METROPOLITAN GOVERNMENT OF NASHVILLE AND DAVIDSON COUNTY

STAFF RECOMMENDATION
1416 Gartland Avenue
May 16, 2012

Application: New Construction - additions
District: Lockeland Springs-East End Neighborhood Conservation Zoning Overlay
Council District: 06
Map and Parcel Number: 08309034100
Applicant: Peggy Newman
Project Lead: Sean Alexander, sean.alexander@nashville.gov

Left chimney, current photo.

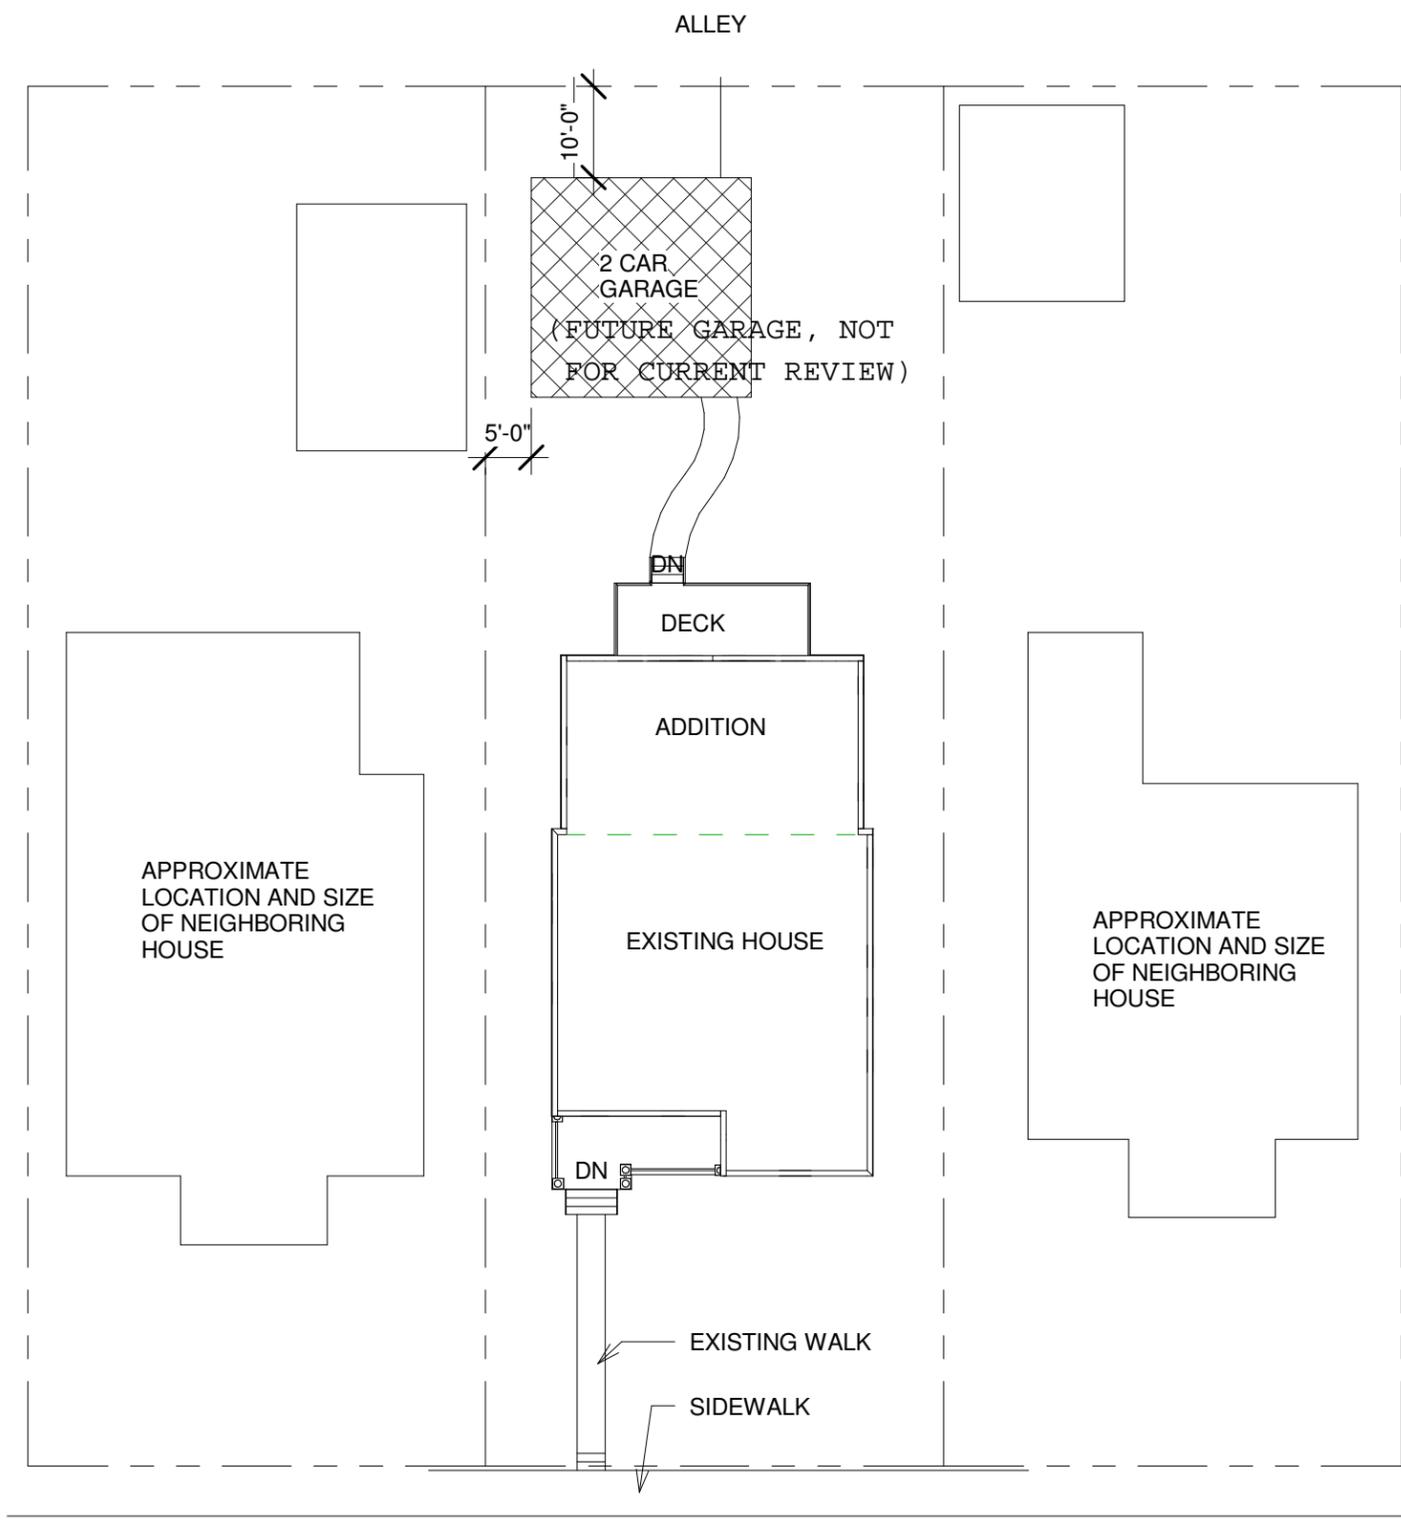
New hipped dormers are also proposed, one on each side slope of the historic house. The new side dormers will match the form and size of an existing front dormer, which also meets guidelines II.B.1 and II.B.2 as well as II.B.10. However, the left dormer would require the removal of an existing severely damaged chimney. Side dormers are not appropriate when they require the removal of an architectural feature. Staff recommends against approval of the new left dormer. A rear chimney will also be removed, which is appropriate because it is not visible from the right of way and is not a character defining feature.

Staff recommends against approval of the new left side dormer because it would require the removal of an original chimney, which would not meet the design guidelines.

GARTLAND
SITE PLAN 1" = 20'

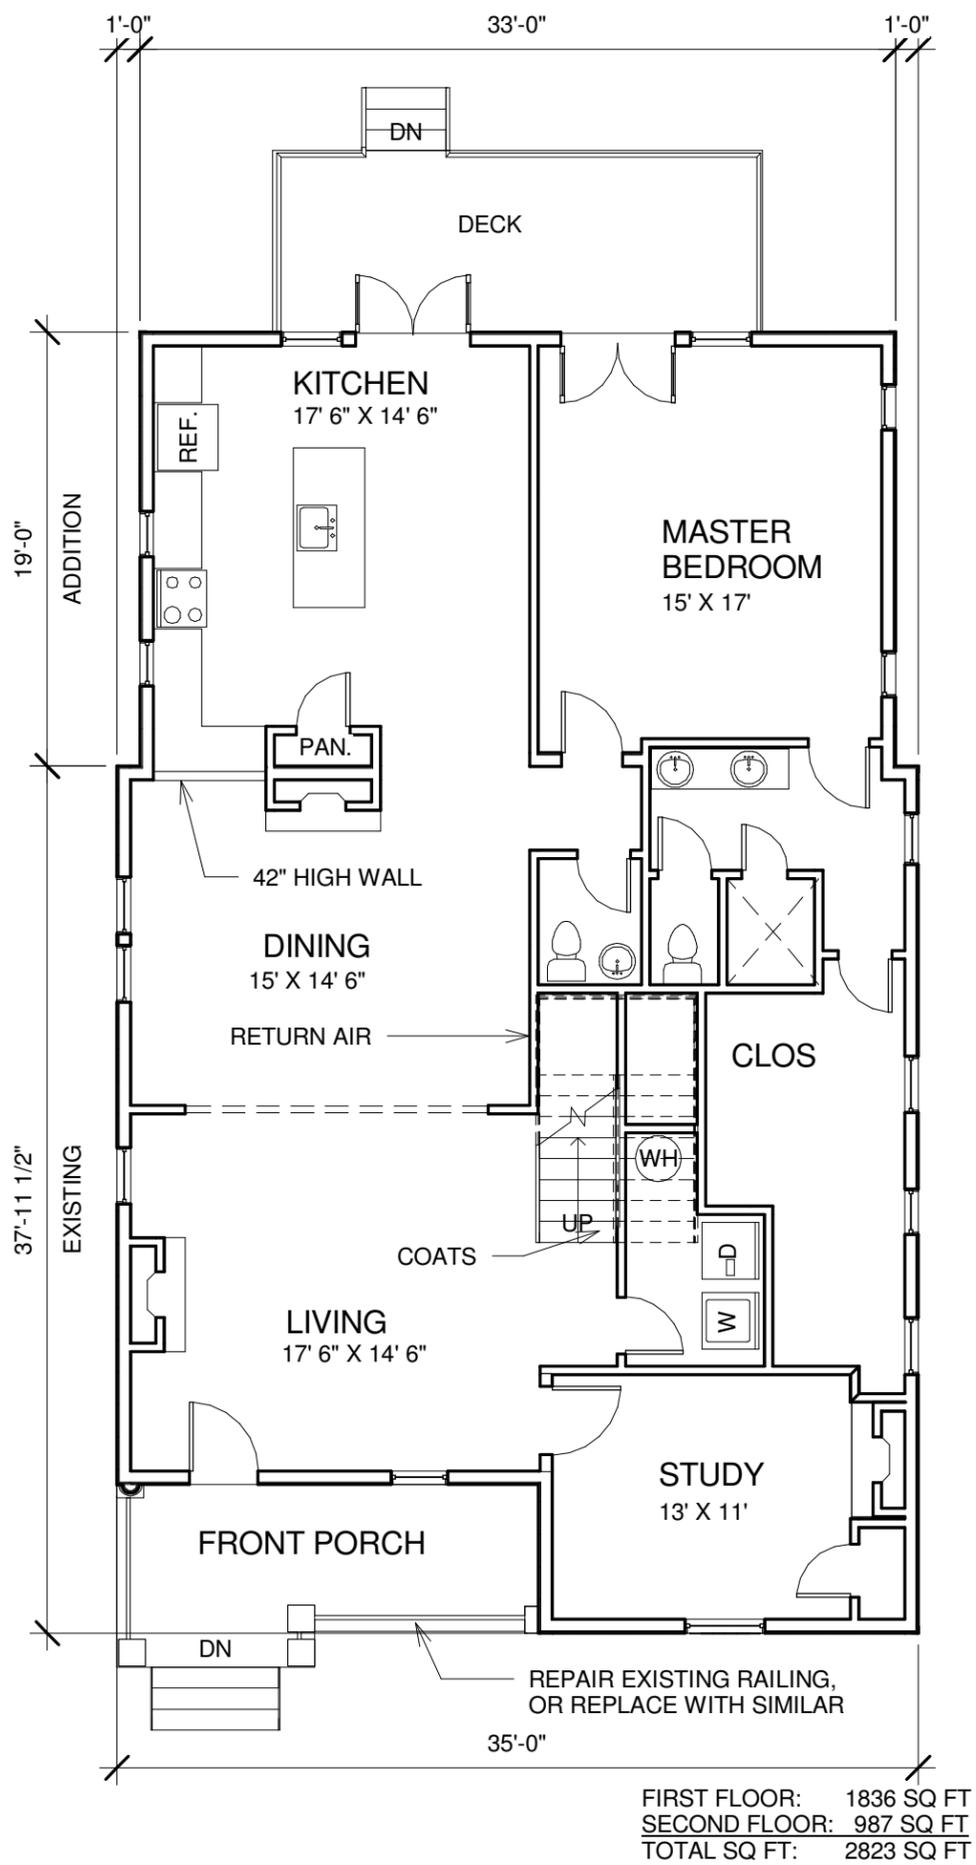
Setback and Rhythm of Spacing: Because the addition sets in one foot (1') from the sides of the house and will be no less than eight feet (8') from the side property boundaries, it will not disrupt the street rhythm established by historic houses. Staff finds the proposal to meet guideline II.B.3.

LEFT ELEVATION - 1/8" = 1'-0"
1416 GARTLAND AVE, NASHVILLE, TN

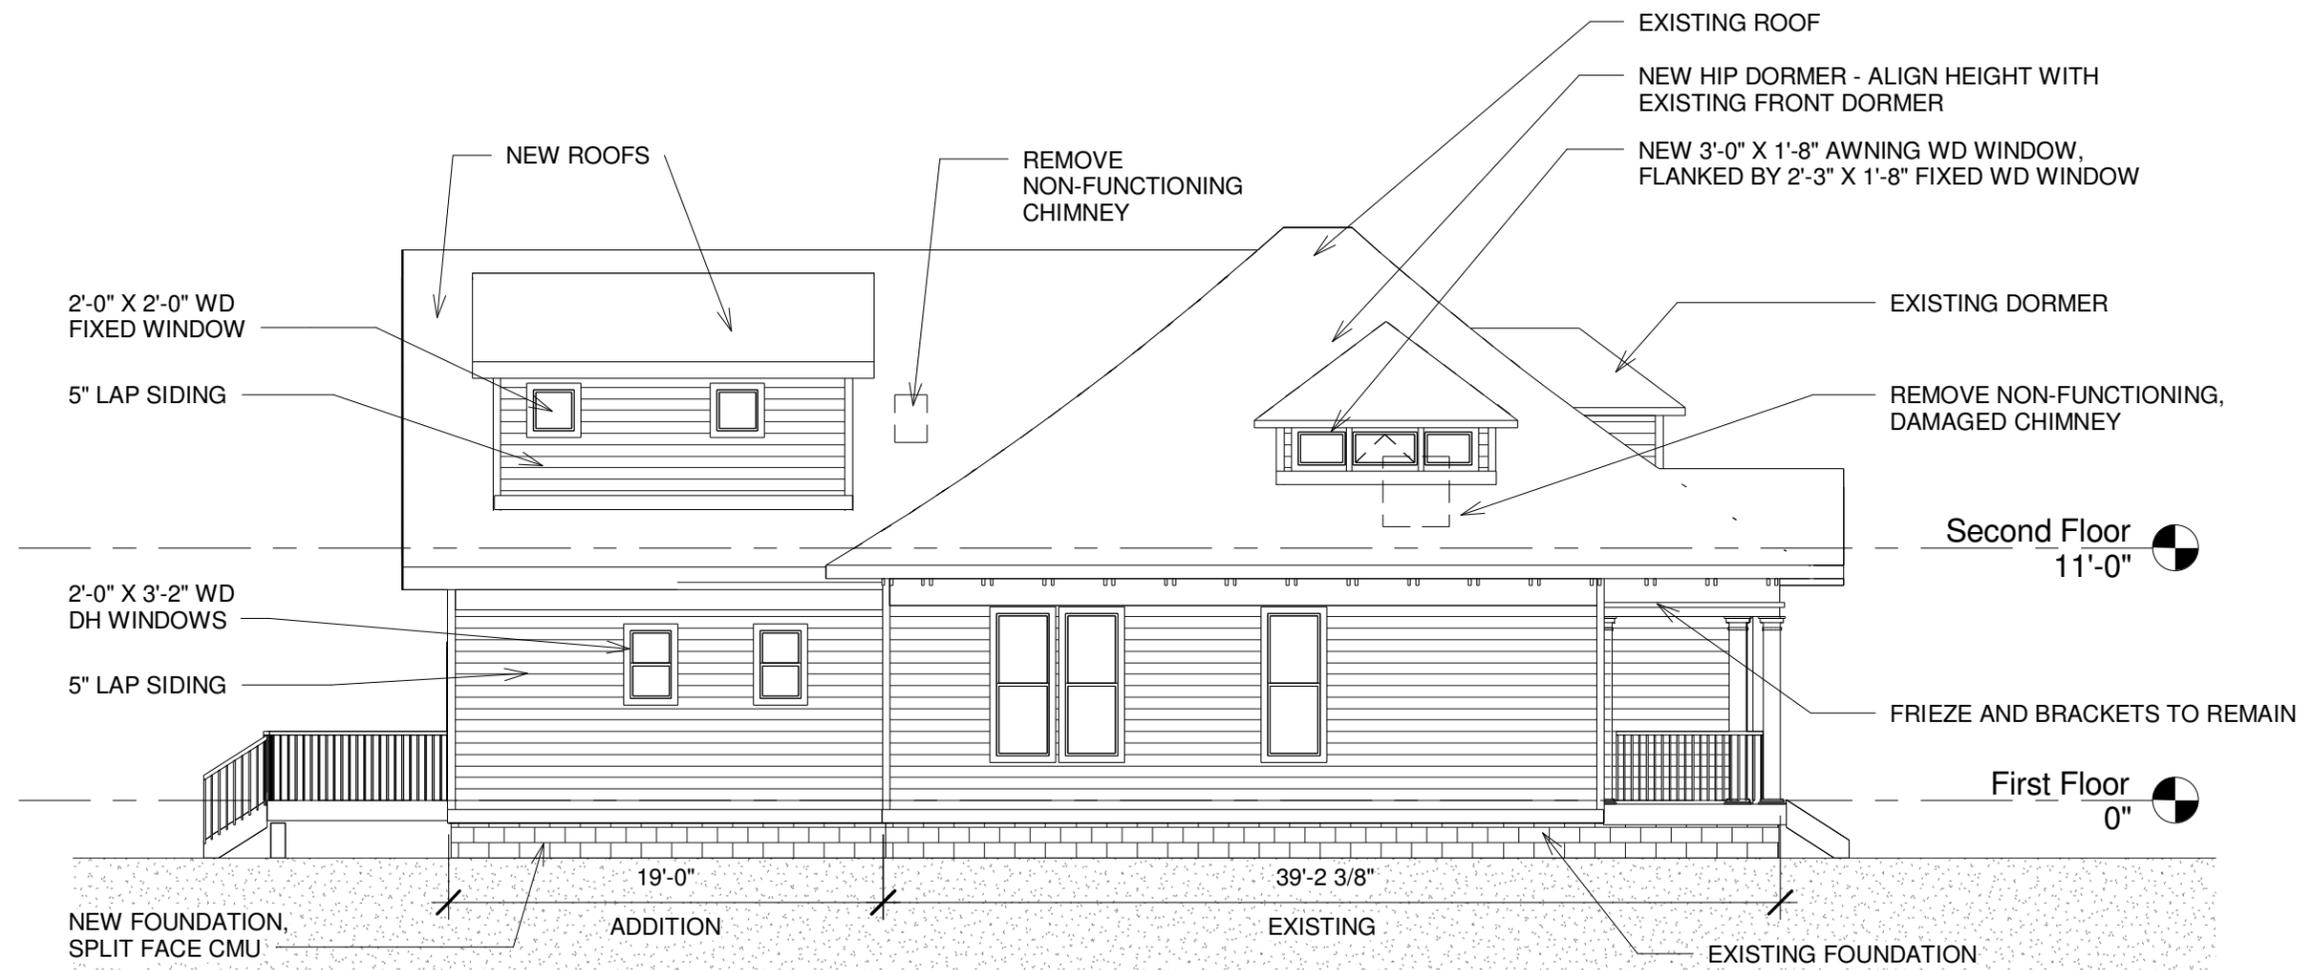
Height, Scale of Additions: The rear addition will set in one foot (1') from the outside walls of the house on each side and extend nineteen feet (19') to the rear. The roof of the addition will be a rear-facing gable, matching the pitch of the existing roof with the ridge set one foot (1') below the existing ridge. There will be a shed roof dormer on each of the side slopes of the new roof, originating behind the rear wall of the historic house. These walls of these dormers will set in two feet (2') from the walls below. Staff finds the height and scale of the addition to be compatible and subordinate to the historic house, and to meet guidelines II.B.1 and II.B.2

Roofs: The rear facing gable and the new dormers on the existing roof will match the pitch of the existing roof. The shed-roofs on the dormers on the addition will have a 3:12 pitch, which is compatible with the roofs of historic shed-roofed dormers. Staff finds these roofs to be compatible with those of surrounding historic houses and meet guideline II.B.5.

Proportion and Rhythm of Openings: On the first-story of the addition, there will be two windows on each side wall, consistent with the rhythm of windows on the historic house. The windows on the left side will be vertically-oriented rectangles and the windows on the right side will be square. Windows typically need to be twice as tall as wide, but staff does not find these windows to significantly contrast with surrounding historic houses

Recommendation: Staff recommends approval of the application to construct a rear addition and right side dormer at 1416 Gartland Avenue, finding the application to meet the design guidelines for New Construction and Additions in the Lockeland Springs-East End Neighborhood Conservation Zoning Overlay.

RIGHT ELEVATION - 1/8" = 1'-0"
1416 GARTLAND AVE, NASHVILLE, TN

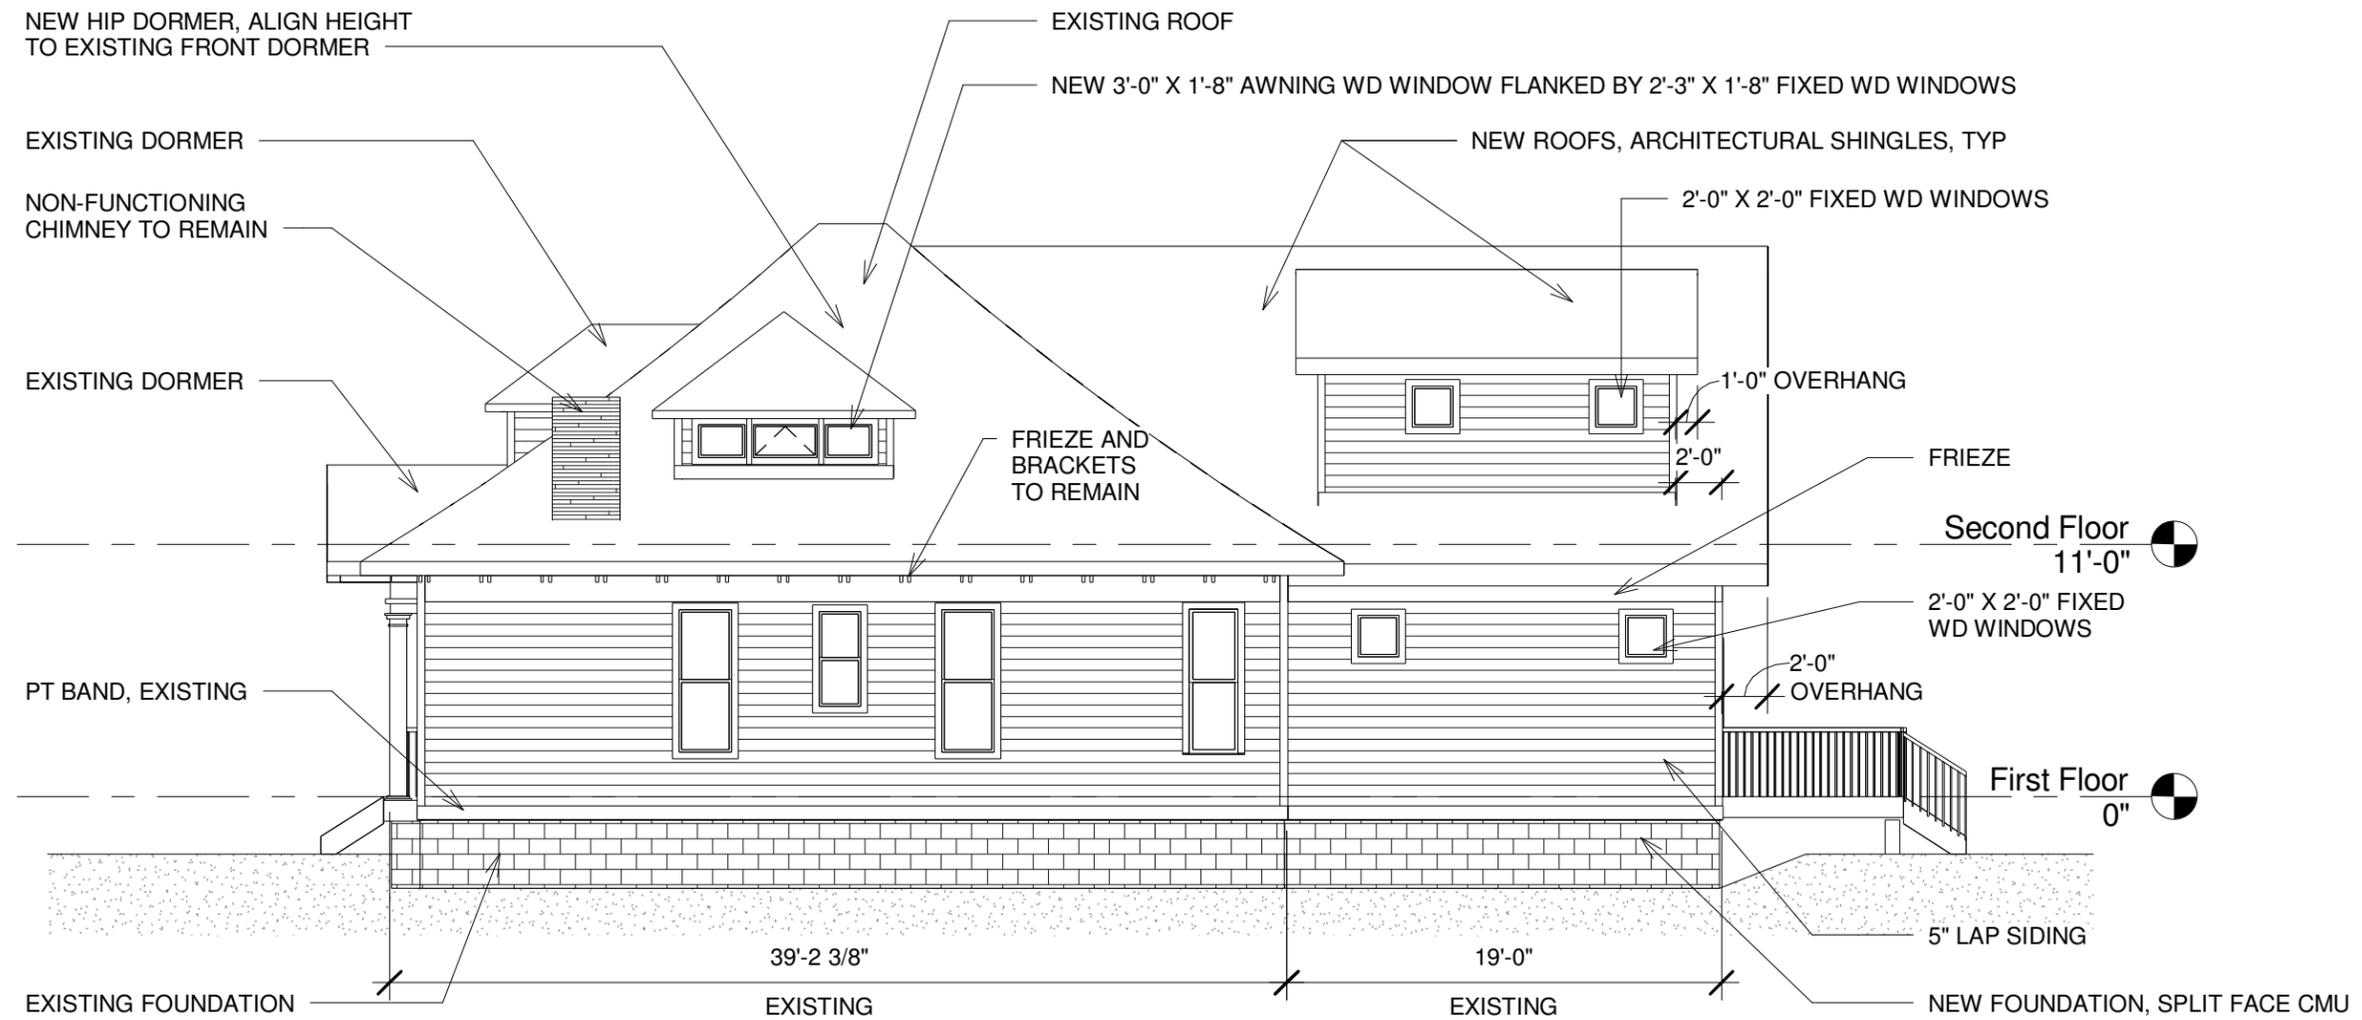
because their impact and visibility is minimal behind a forty foot (40') long wall of the historic house. Staff finds the proposal to meet guideline II.B.7.
